Well Name: SAN JUAN 29-5 UNIT	Well Location: T29N / R5W / SEC 18 / NESE / 36.723796 / -107.392658	County or Parish/State: RIO ARRIBA / NM
Well Number: 68M	Type of Well: CONVENTIONAL GAS WELL	Allottee or Tribe Name:
Lease Number: NMSF078281	Unit or CA Name: SAN JUAN 29-5 UNIT--DK, SAN JUAN 29-5 UNIT--MV	Unit or CA Number: NMNM78415A, NMNM78415B
US Well Number: 3003926577	Operator: HILCORP ENERGY COMPANY

Type of Submission: Notice of Intent

Type of Action: Recompletion

HILCORP ENERGY COMPANY
SAN JUAN 29-5 UNIT 68M
FRUITLAND COAL & PICTURE CLIFFS RECOMPLETION SUNDAY

SAN JUAN 29-5 UNIT 68M - PROPOSED WELBORE SCHEMATIC

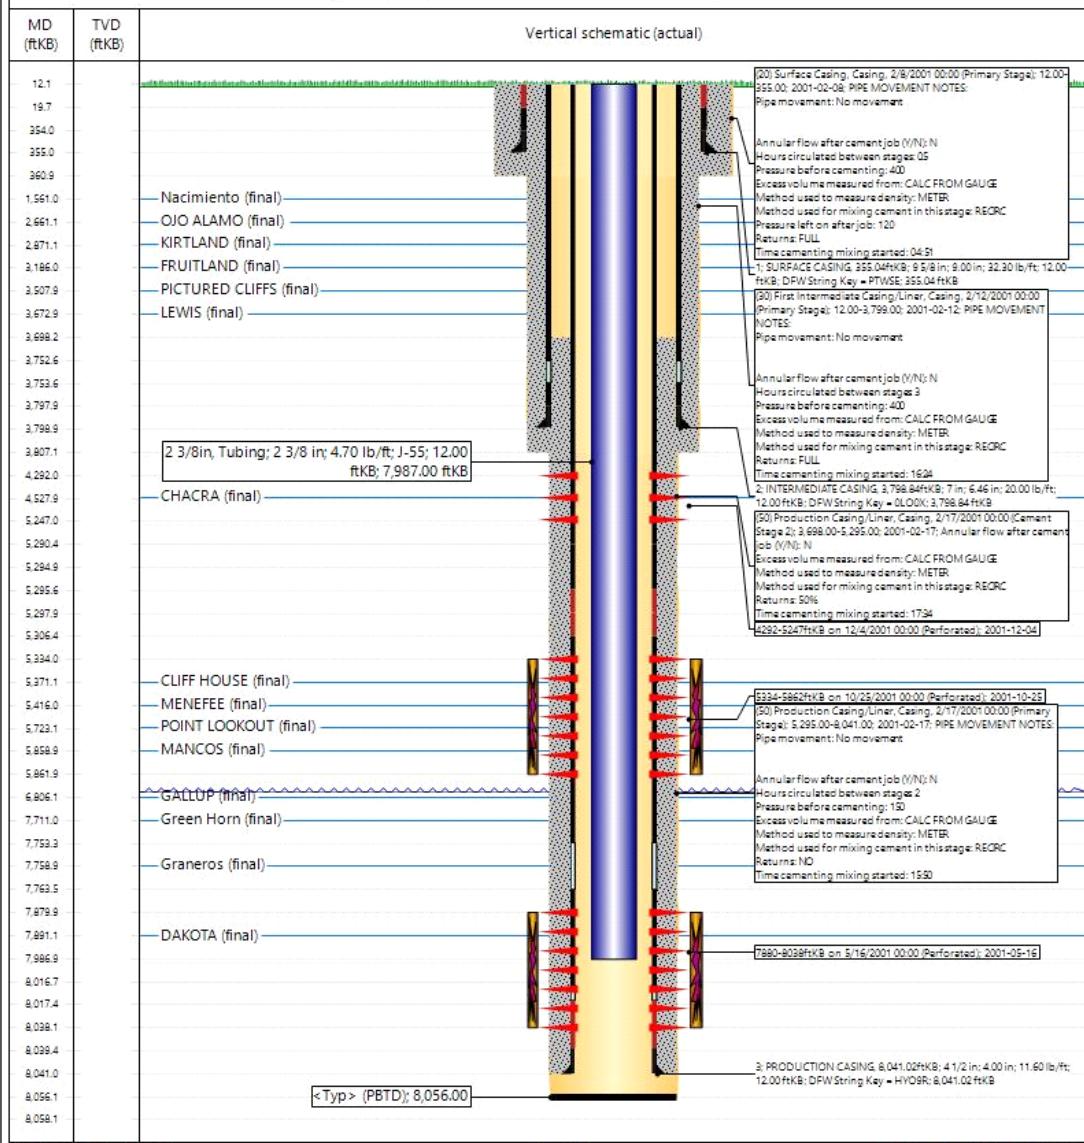
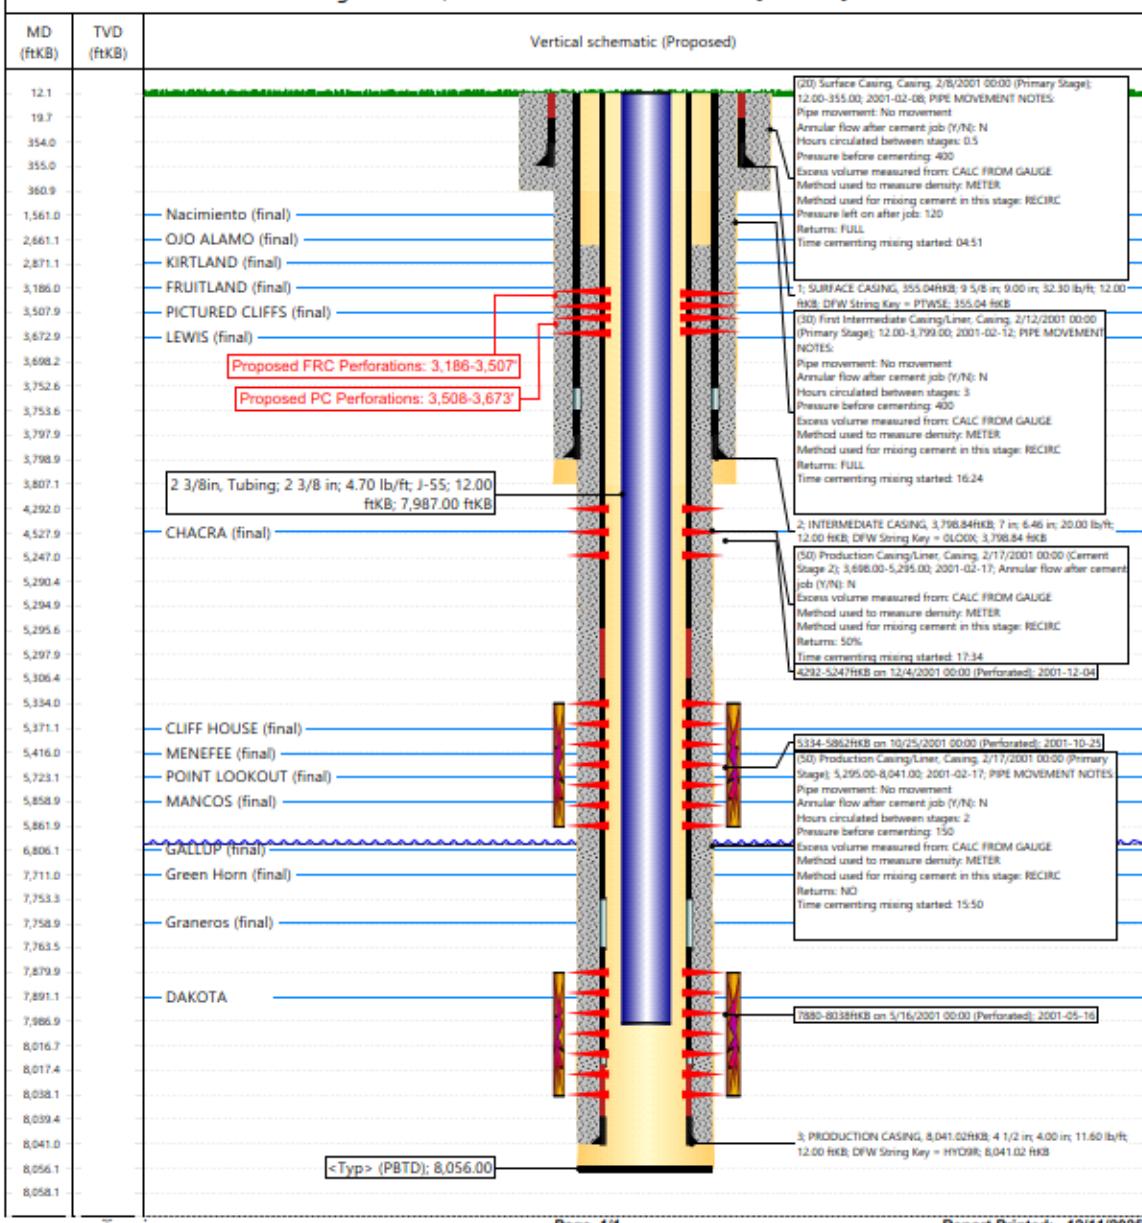
Procedure Description: Hilcorp Energy Company requests to revise the previously approved NOI to recomplete the subject well in the Fruitland Coal, to now include the Pictured Cliffs and downhole commingle with the existing MV/DK. Please see the attached revised procedure, current and proposed wellbore diagram, plat and natural gas management plan. A closed loop system will be used. A pre-reclamation onsite is not required as the surface is Fee.

1. MIRU service rig and associated equipment.
2. Nipple down wellhead, nipple up and test BOPs per HEC, State, and Federal guidelines.
3. TOOH with 2-3/8" tubing
4. **Set a 4-1/2" bridge plug at 5,283' to isolate the Mesaverde and Dakota formations. The BP must be set within 50 ft of the top MV perforation.**
5. RU pressure test truck. Perform a Mechanical Integrity Test on the wellbore above the plug at 4,770'. Chart record the MIT test (notify BLM and NMOCD +24hr before actual test).

6. Perforate for circulating squeeze at 3,210 ft. Establish circulation to surface, and circulate a column of cement to adequately cover the Fruitland Coal interval +150 ft.

8. NDNU frac stack. Pressure test casing and frac stack to frac pressure.
9. **RU E-Line Crew. Perforate the Fruitland Coal from 3,186' to 3,507' and Picture Cliffs from 3,508' to 3,673'.**

12. **Pending C107A approval**, drill out stage plugs and Mesaverde isolation plug. Clean out to PBTD at **8,038'**. TOOH w/cleanout assembly
13. TIH and land 2-3/8" production tubing. Run pump and rods, install pumping unit.
